ADDENDUM #2

Reference: Greendale Maintenance Station Replacement
Utah Department of Transportation – Daggett County, Utah
DFCM Project No. 07029900

Subject: **Addendum No. 2**

2.4.1 The complete **drawing set has been revised and is re-issued with this Addendum.** Owner requested the deletion of the mezzanine and mezzanine access. Walls around office area extend 18'-0" A.F.F. Building footprint has been revised to incorporate larger truck bays. All drawings for all disciplines have been revised showing new building footprint & layout.

C200

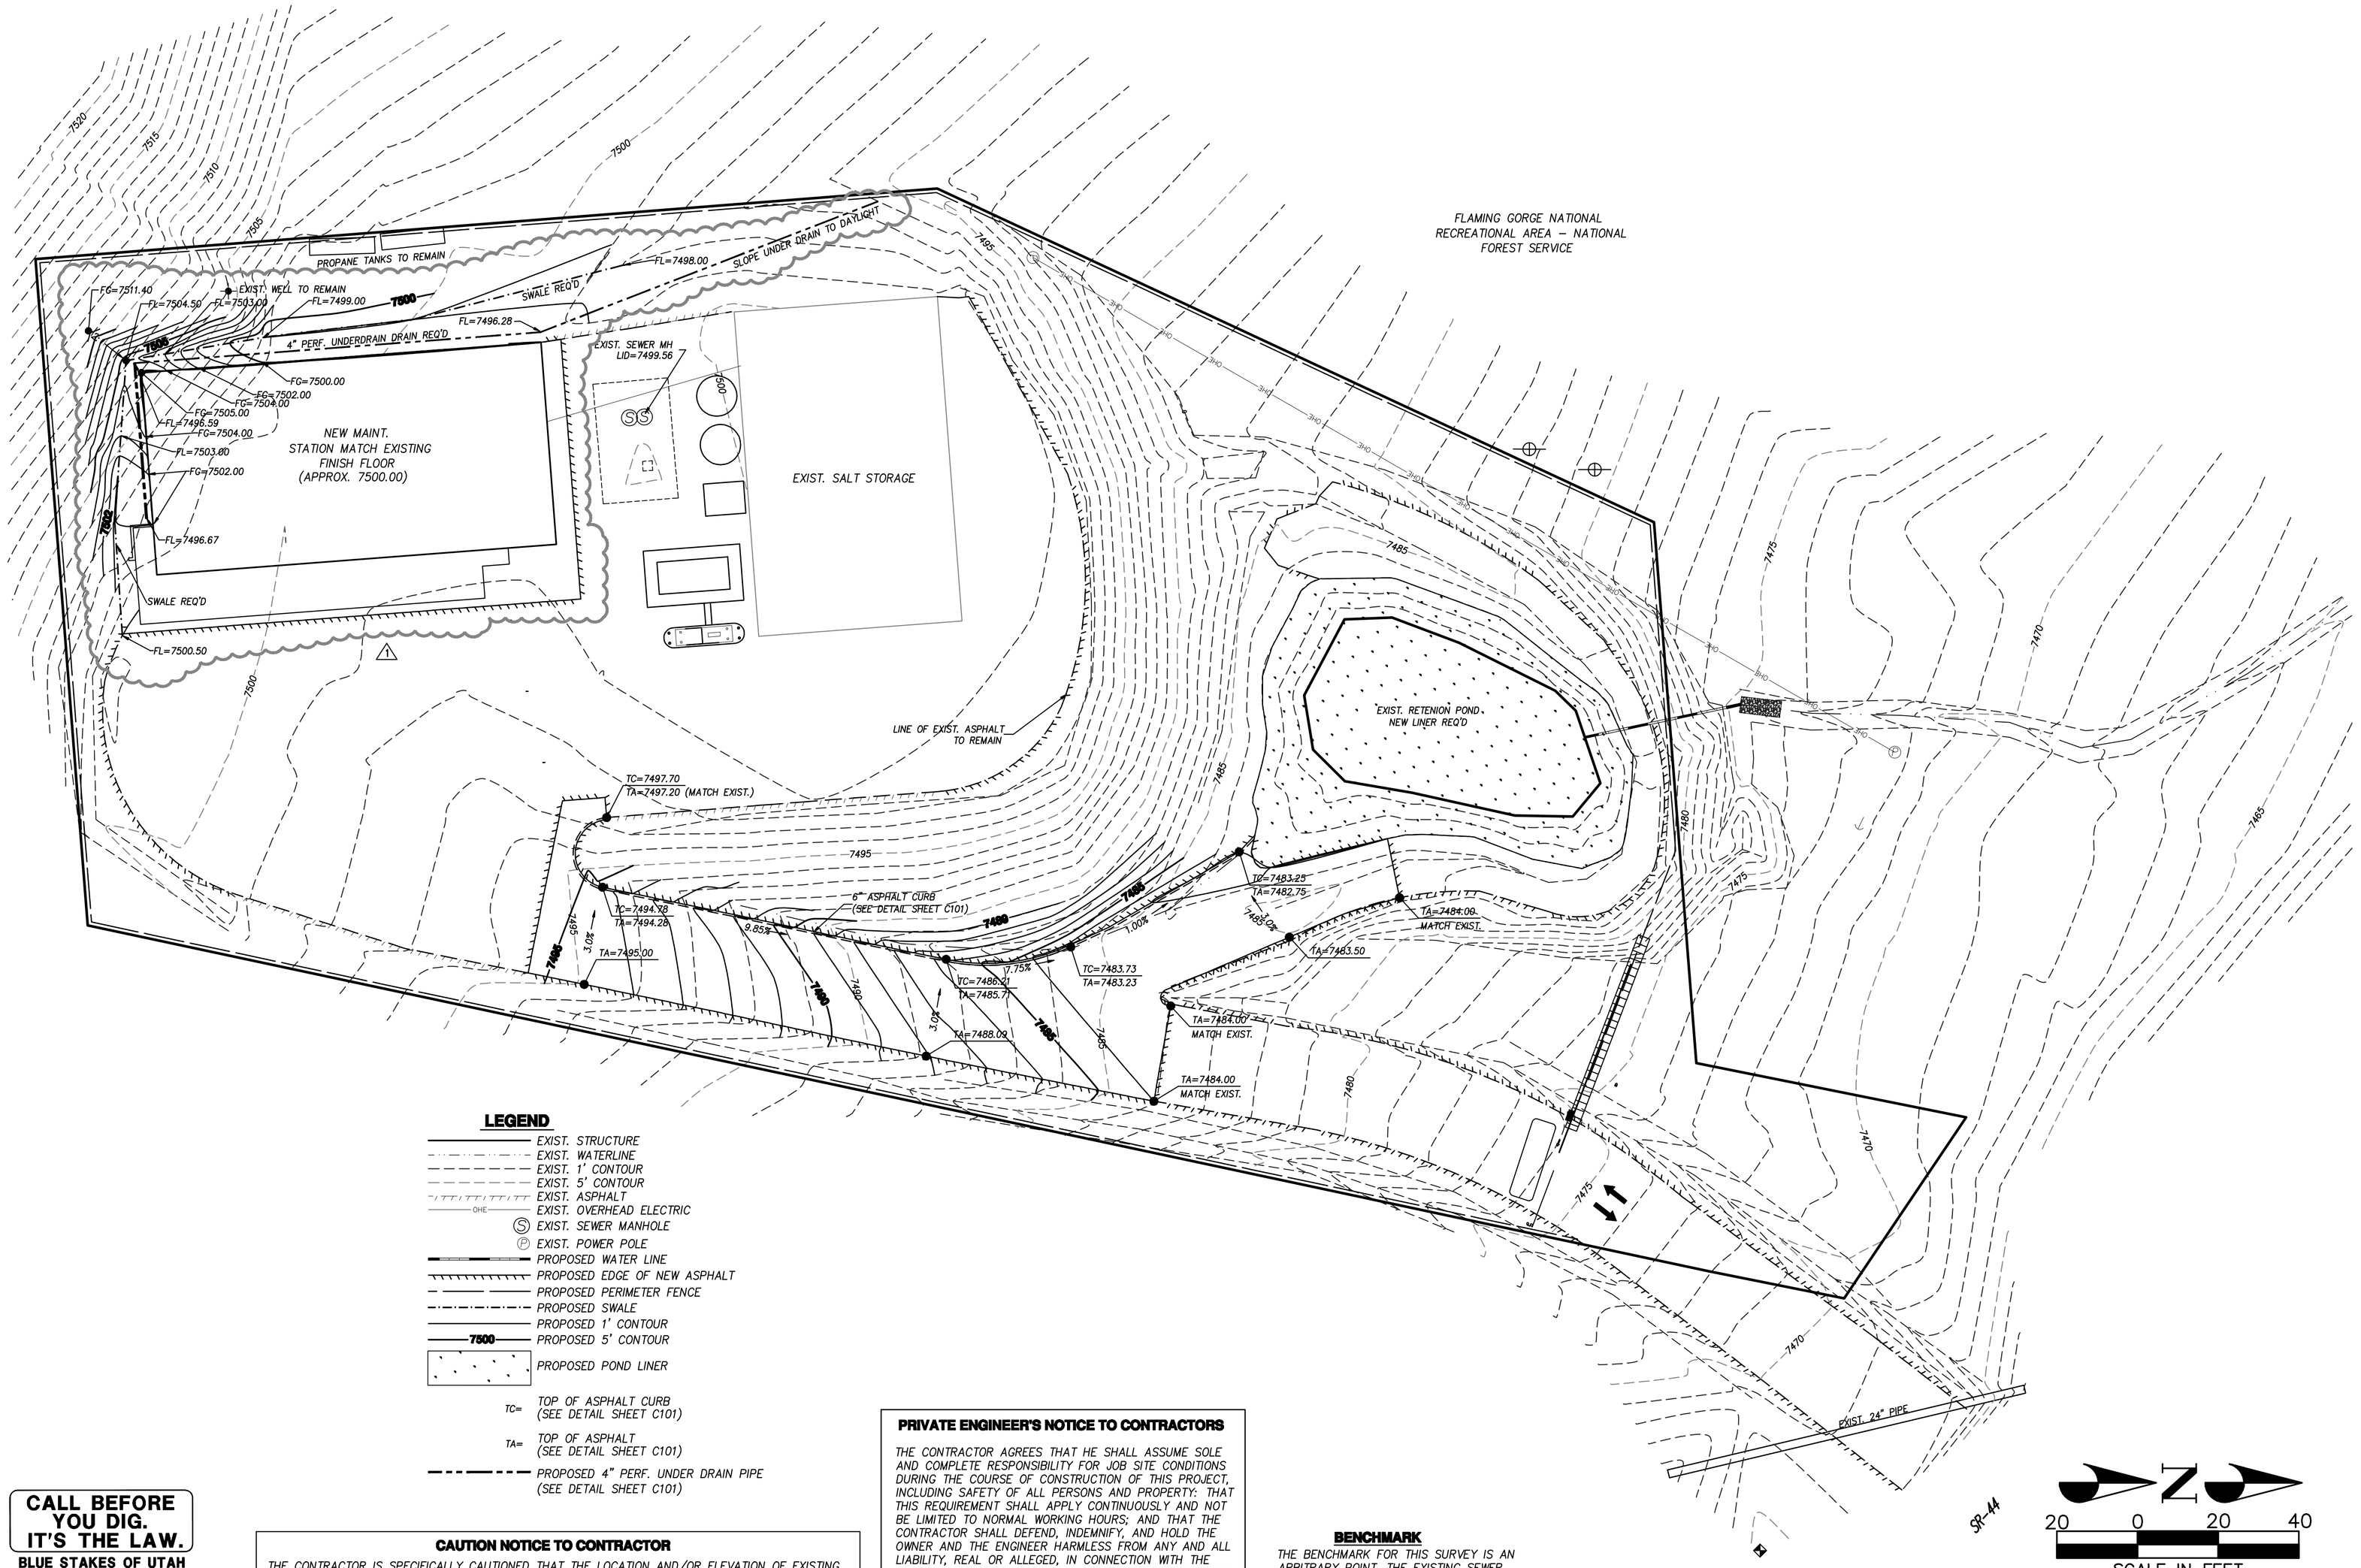
a. Site grading revised to accommodate larger building.
b. Swale on north side of building re-aligned to north.
c. 4” Under drain added around north and west sides of new building.

C201

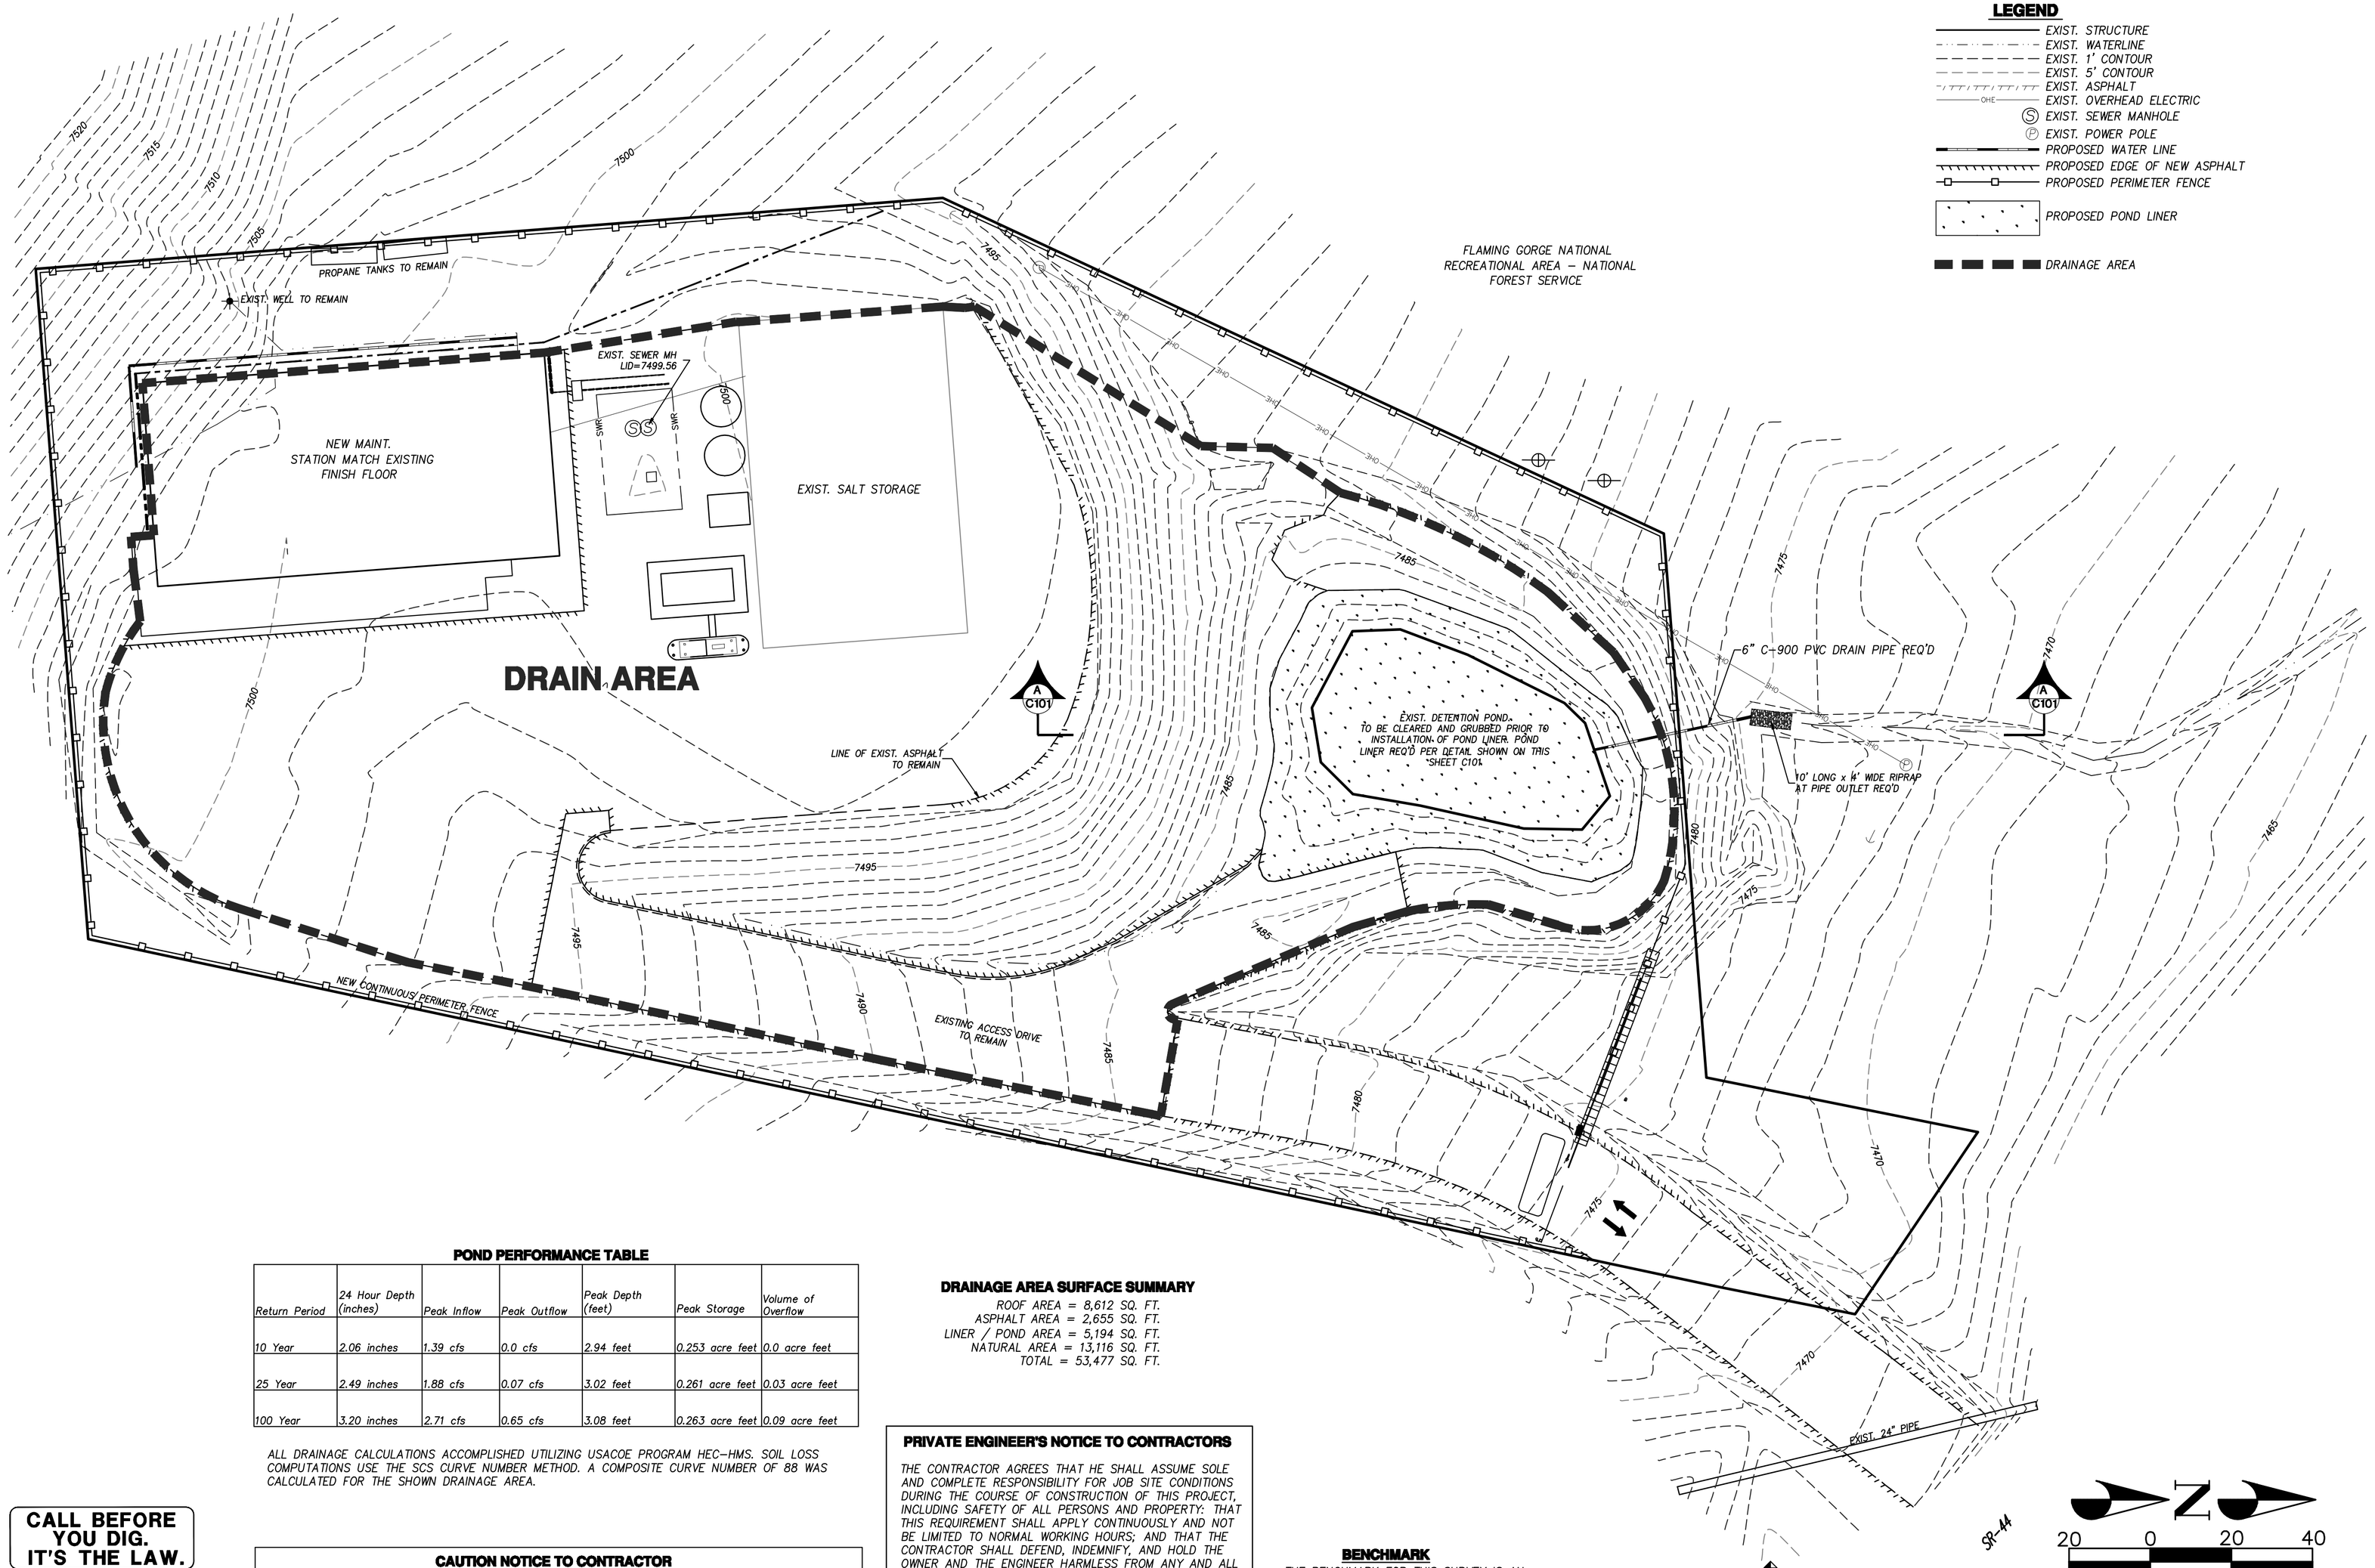
a. New building footprint added.

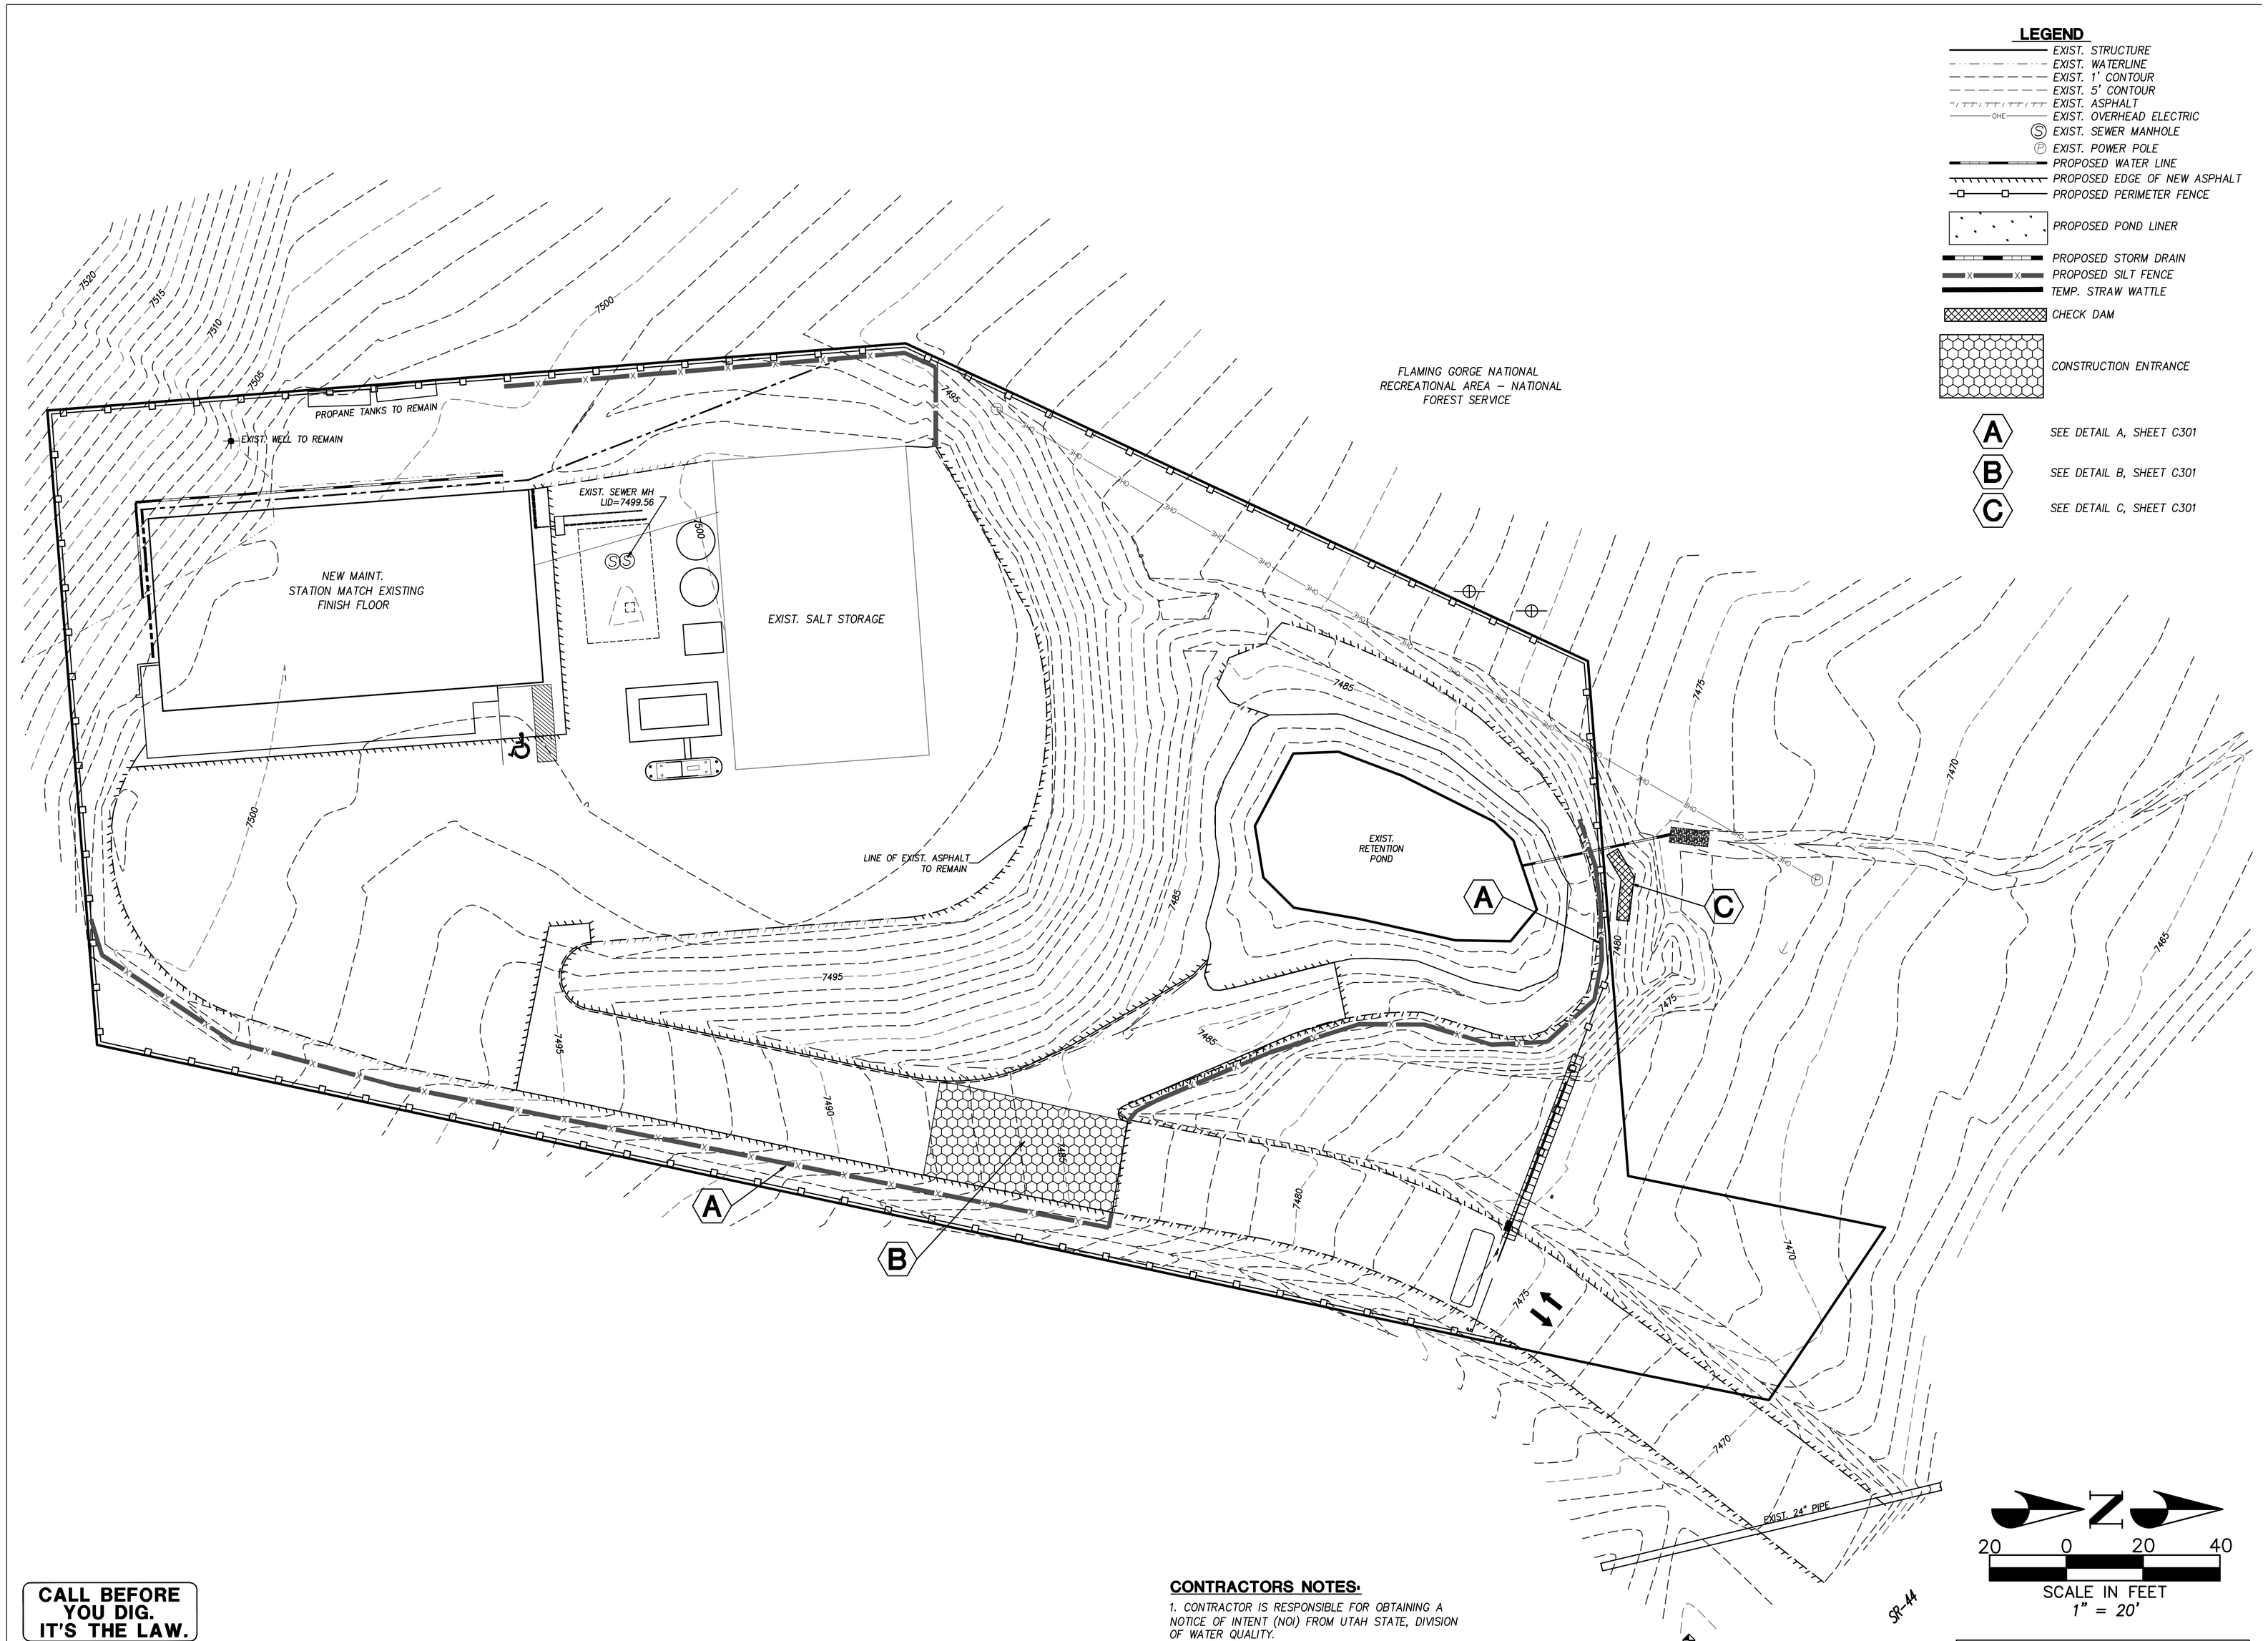
a. New building footprint added.
b. Erosion control fence revised along north side of swale where under drain will be installed.
